Alaska Housing Finance Corporation

Alaska-Specific Amendments to IRC 2018

November 28, 2018

Appendix I.2 Continuous Cedar Block

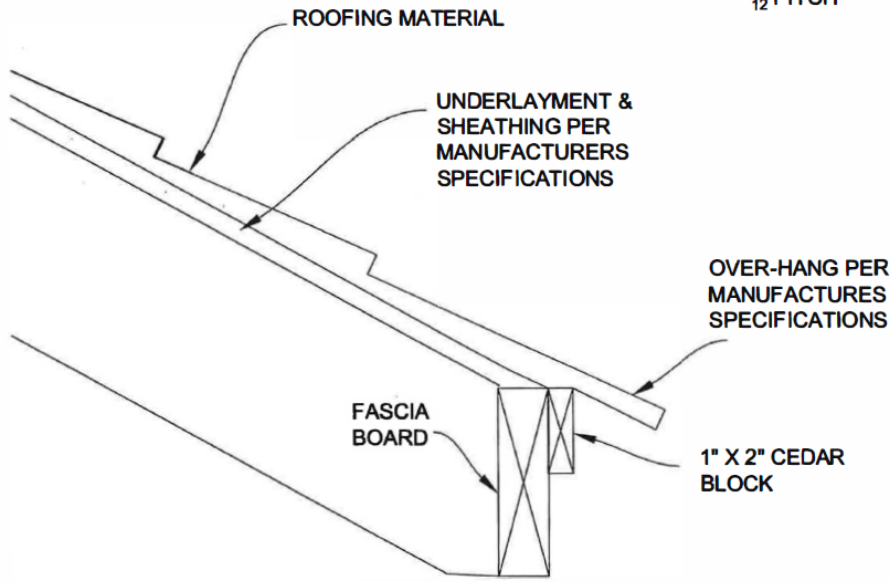
Exception: Allowing for best practices in covering all plywood edges on roofs with a slope equal or greater than four (4) units vertical in twelve (12) units horizontal (4:12) a full length fascia or a 1" by 2" continuous cedar block may be used as a drip edge (See appendix 1). Sheathing, underlayment and roofing materials shall be installed per the manufactures recommendations. (see Appendix 1.1 and Appendix 1.2)
